SEPTIC SYSTEM PERMIT

FLATHEAD CITY-COUNTY HEALTH DEPARTMENT

97-2608R

Property Address 67 Old Bridge Street, Bigfork, MT

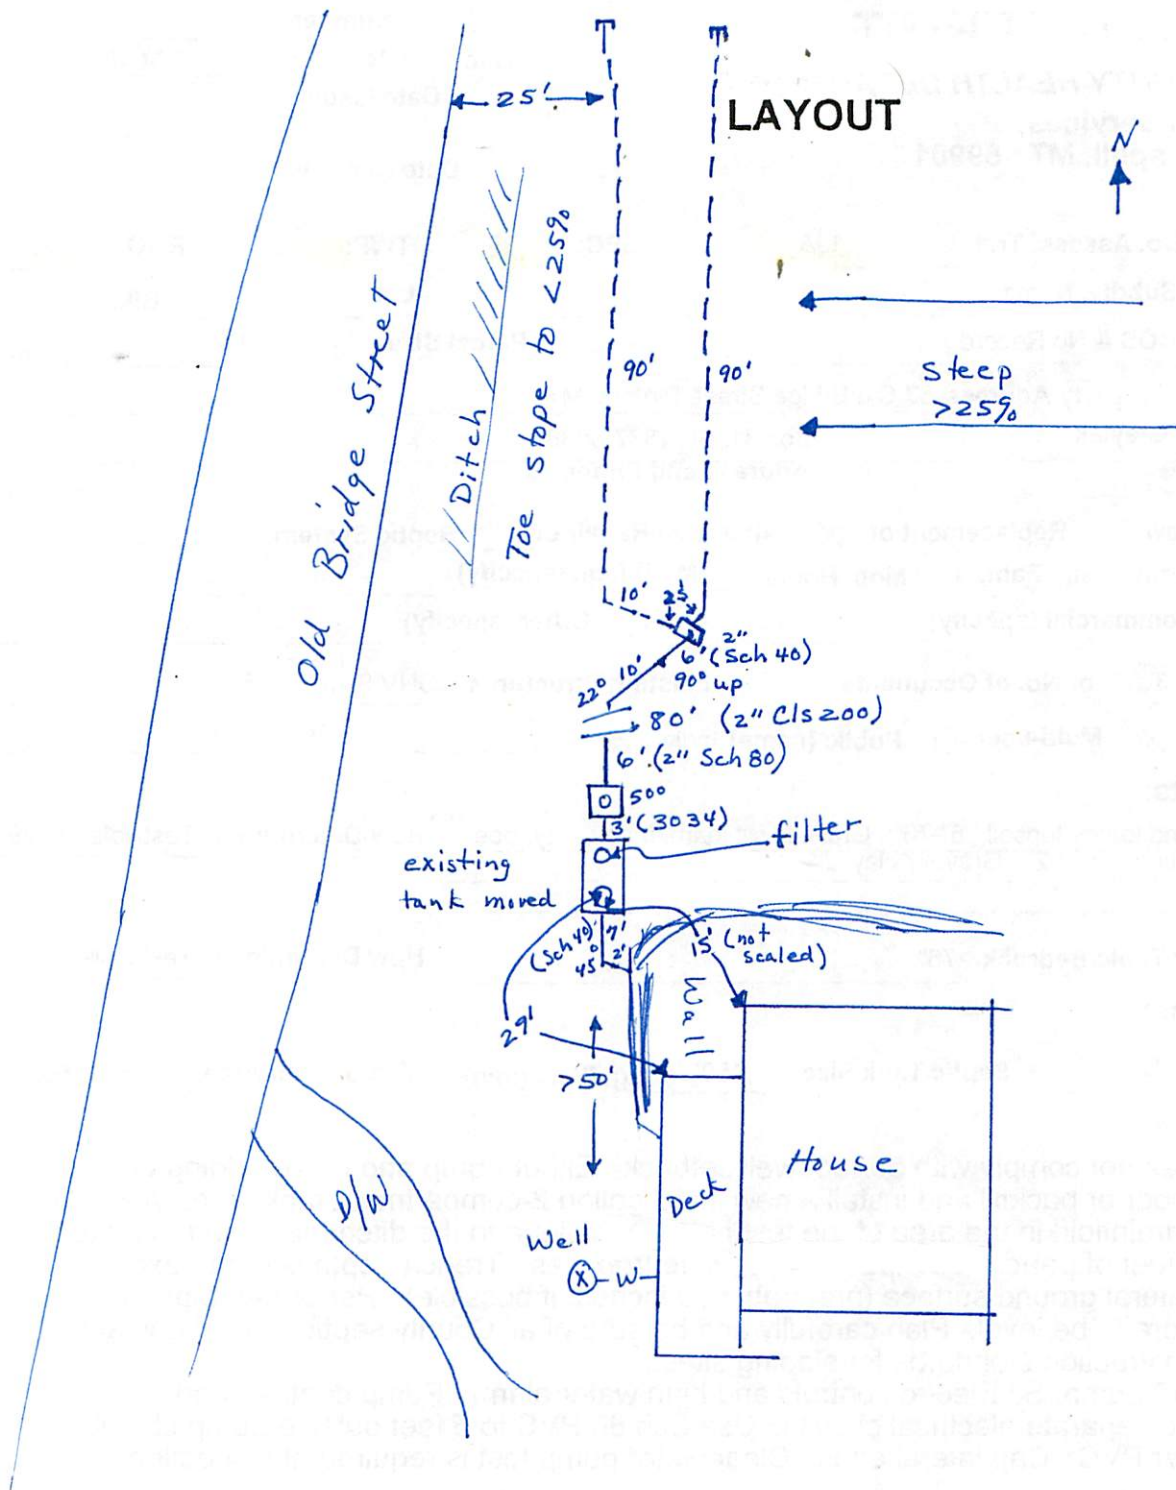
Existing septic tank does not comply with 50-foot well setback. Either pump and move adding on a 500-gallon pump chamber or backfill and install a new 1500 gallon 2-compartment tank complying with setback. Located the drainfield in the area of the test hole. The slope to the ditch may need to be toed to <25%. Use 200 lineal feet of perforated pipe in 3-foot wide trenches. Trench depth is not to exceed 36 inches below the natural ground surface (preferably 30 inches, if possible). Perforated pipe and lateral trench bottoms are to be level. Plan carefully and be sure of all County septic regulations and mechanical system construction standards for sloping sites.

Proposed: Myers ME40 pump, SJ Electro controls and high water alarm. Pump controls and alarm are to be wired to separate electrical circuits. Use Sch 80 PVC to 5 feet outside pump chamber then Cls 160 or stronger PVC. Cap lateral ends. Clear water pump test is required at inspection.

Comments 190 x 3 = 570 ft²

Controls & pump not connected to electrical circuits
@ inspection. Will toe slope to ditch @ <25%.
Property line assumed @ center of road.
